# UNITED STATES PATENT AND TRADEMARK OFFICE

APPLICATION NO.	FILING DATE	FIRST NAMED INVENTOR	ATTORNEY DOCKET NO.	CONFIRMATION NO.
10/506,675	09/17/2004	Jeannot Hironimus	258372US6PCT	7095
22850	7590	08/03/2007		
OBLON, SPIVAK, MCCLELLAND, MAIER & NEUSTADT, P.C. 1940 DUKE STREET ALEXANDRIA, VA 22314			EXAMINER KOVACS, ARPAD F	
			ART UNIT	PAPER NUMBER
			3671	
			NOTIFICATION DATE	DELIVERY MODE
			08/03/2007	ELECTRONIC

## Office Action Summary

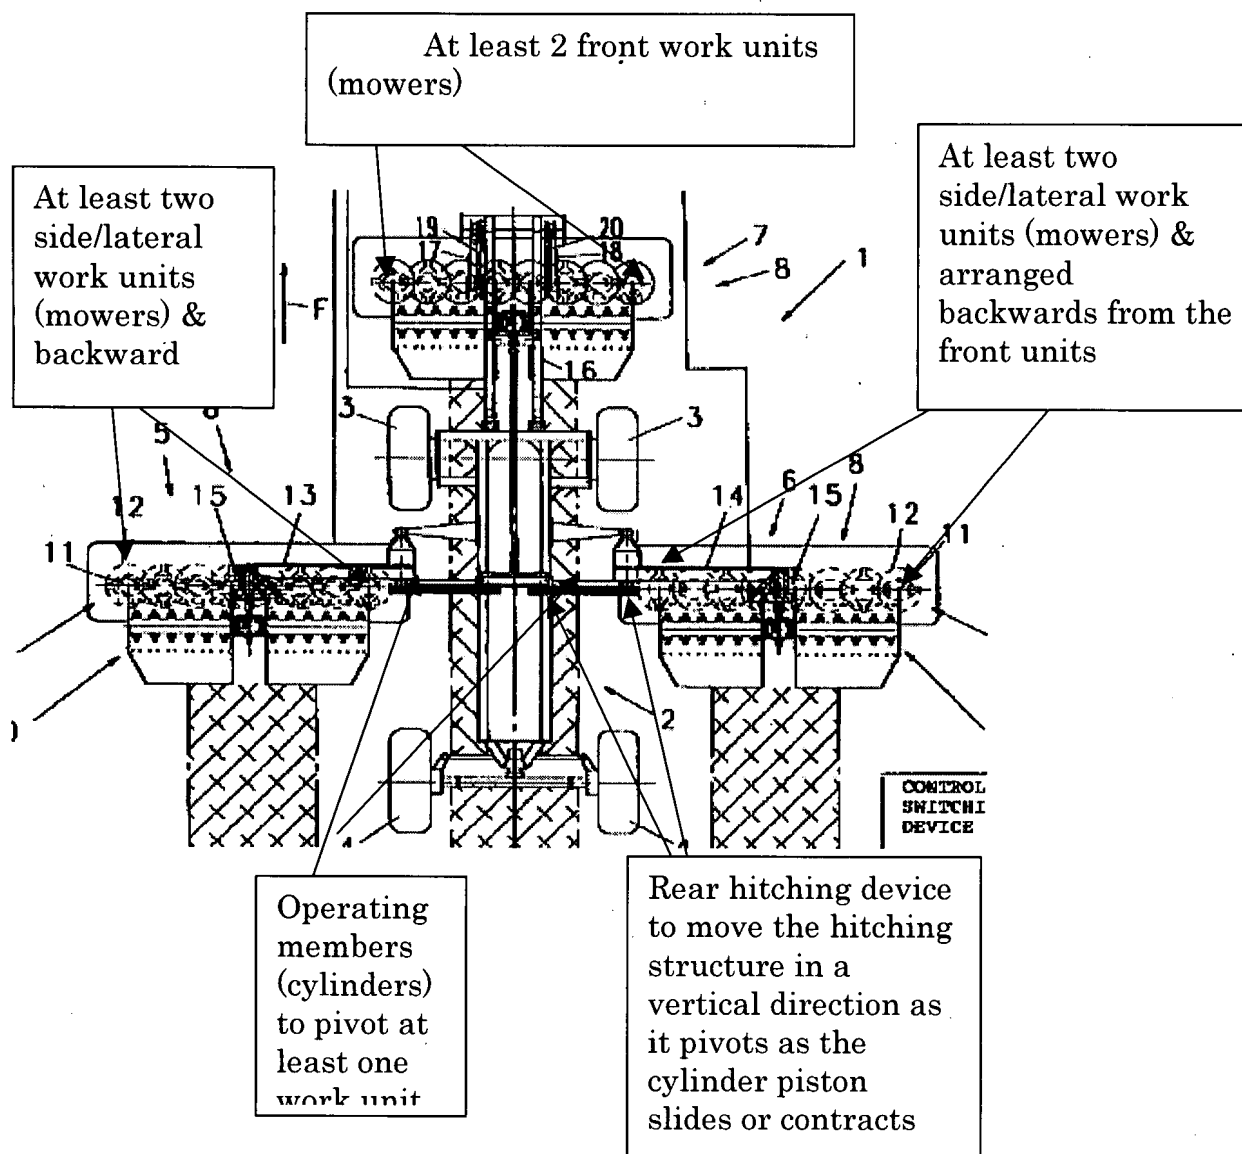
at least two front work units (see drawing below),

at least two lateral work units & outside a work area of the front units (see drawing below);

cl. 30-32, 59-64: the lateral/side units arranged backwards from the front units & offset & outside (see drawing below);

cl. 33-34, 38-41: pivoting at least one work unit by an axis in the direction of the forward travel (see drawing below) into horizontal & vertical positions, an operating member or hydraulic cylinders that connects a carrying arm to a hitching structure in the inherent sliding manner (¶13 & 14):

cl. 42-43: rear hitching device to move the hitching structure in a substantially vertical direction (see fig. above);

cl. 44: the two front work units comprise two front work units (see fig above);

cl. 45: two lateral work units (see fig above);
